**Economic and Social Council**Distr.: General  
27 November 2014

**World Forum for Harmonization of Vehicle Regulations****Working Party on Passive Safety****Fifty-sixth session**

**Global technical regulation No.9 (Pedestrian safety) – Proposal for  
Phase 2 of the global technical regulation****Proposal for amendments to global technical regulation No. 9  
(Pedestrian safety)****Submitted by the expert from the European Commission as Chair of  
the Task Force on Bumper Test Area within the Informal Working  
Group on global technical regulation No. 9 Phase 2\***

"Figure 5A

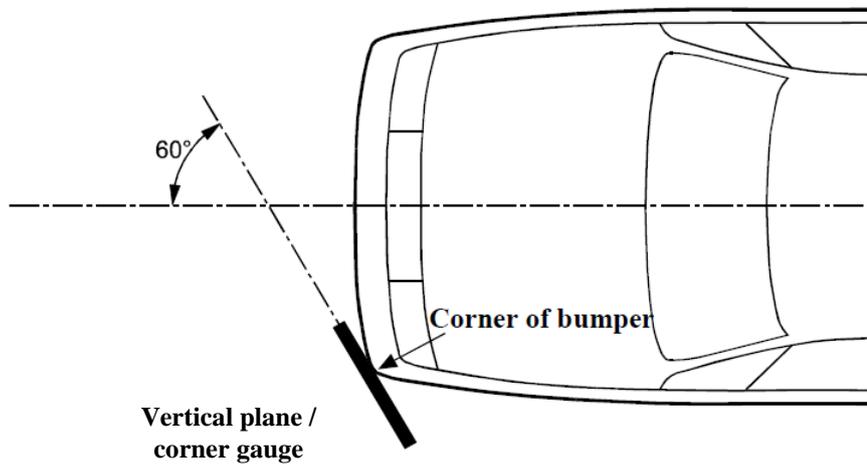
**"3.14. "Corner of bumper" means the transversal position of the vehicle's point of contact with a vertical plane which makes an angle of 60° with the vertical longitudinal plane of the vehicle and is tangential to the outer surface of the bumper (see Figure 5).corner gauge as defined in Figure 5B.**

**For determination of the corner of bumper, the front surface of the corner gauge is moved parallel to a vertical plane with an angle of 60° to the vertical longitudinal centre plane of the vehicle (see Figures 5A and 5C) at any height of the centre point of the corner gauge between:**

**For determination of the corner of bumper, the gauge is moved to contact the outer contour/front fascia of the vehicle touching at the vertical centre line of the gauge. The horizontal centre line of the gauge is kept parallel to the ground plane.**

**The corners of bumper on both sides are subsequently defined as the outermost points of contact of the gauge with the outer contour/front fascia of the vehicle as determined in accordance with this procedure. Any points of contact on the top and the bottom edges of the gauge are not taken into account. The rear and side view mirrors and the tyres shall not be considered."**

**Corner of bumper example (see paragraph 3.14., note that the corner gauge is to be moved in vertical and horizontal directions to enable contact with the outer contour and front fascia of the vehicle)**

Figure 5B

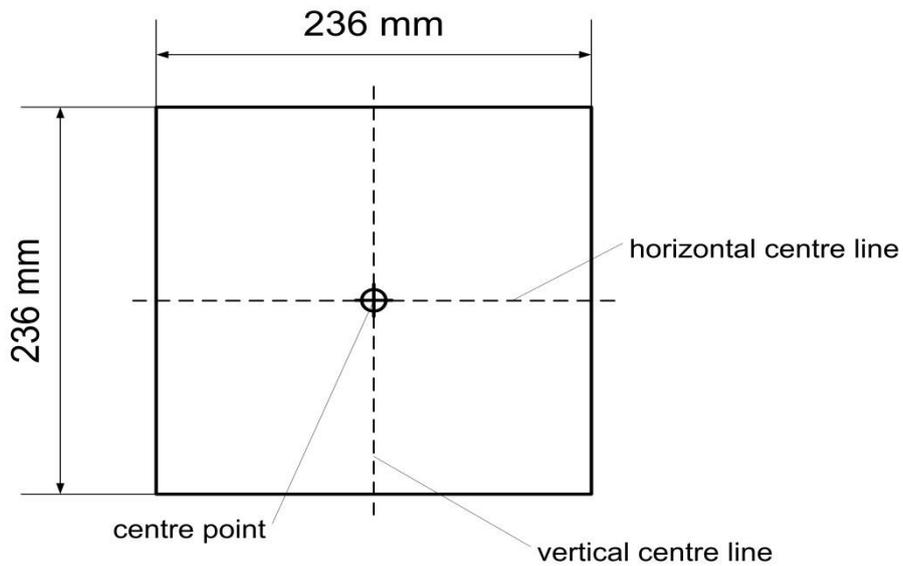
**Corner gauge**

**The front surface of the corner gauge is flat.**

**The centre point is the intersection of the vertical and horizontal centre lines on the front surface.**

Figure 5D  
**Determination of bumper test area (note that the corner gauges are to be moved in vertical and horizontal directions to enable contact with the outer contour and front fascia of the vehicle)**

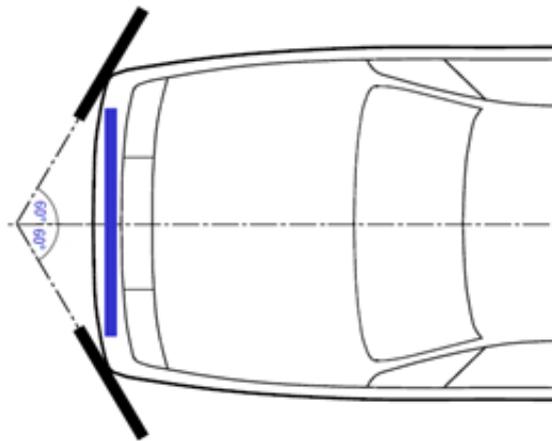
**"3.11. "Bumper test area" means the frontal surface of the bumper limited by two longitudinal vertical planes intersecting the corners of the bumper and moved 66 mm parallel and inboard of the corners of the bumpers. either the front vehicle fascia between the left and right corner of bumper as defined in paragraph 3.14., minus the areas covered by the distance of 42 mm inboard of each corner of bumper, with this distance to be set from the most outboard point with a flexible tape held tautly along the outer surface of the vehicle, or the outermost ends of the bumper beam as defined in paragraph 3.9. (see Figure 5D), whichever area is wider."**
